SERVICE BULLETIN #131

3/16/15

7622 Trailer Spoke Wheel

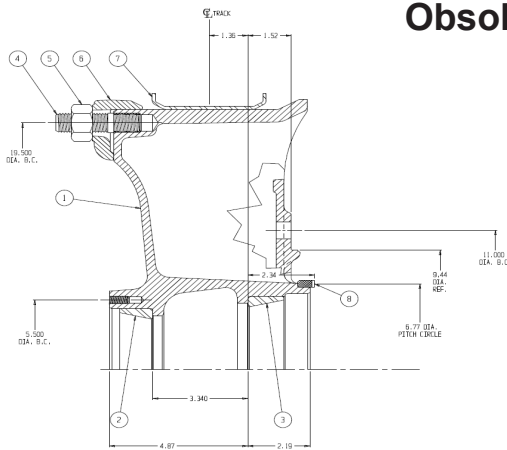
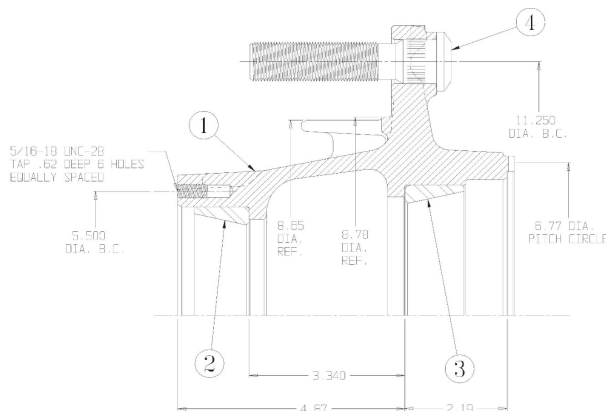
Upon depletion of inventory, the 7622 trailer spoke will become obsolete with no direct replacement. We do however recommend a replacement: the 10-stud 2023 hub. This requires changing brake drums, changing to a disc hub, and changing to disc wheels instead of demountable rims. If you have any questions, please contact Webb Technical Services via email to engineering@webbwheel.com or call (256)739-6660.

Replacement Option

2023 Bill of Material			
Item	Part No.	Description	Qty
1	2023A	10 Stud 11.25" Outboard Hub	1
2	HM212011	Outer Bearing Cup	1
3	HM218210	Inner Bearing Cup	1
4	Varies	Serrated Stud (M22x1.5 or 3/4-16)	10

REPLACEMENT ASSEMBLIES		
Hub Service Assembly	Wheel Type	ABS
20231--MLT	BSN Steel or Aluminum	DMABS
20231--MRT		DMABS
20231--OT	No Studs	DMABS
20231--3T	FN-Steel	DMABS
20231--5T	FN-Aluminum	DMABS

Replacement Drum Numbers	Brake Size
61577B	15.00" x 7.00"
61988B	15.00" x 8.62"
66864B	16.50" x 7.00"
66800B	16.50" x 8.00"
66855B	16.50" x 7.00"
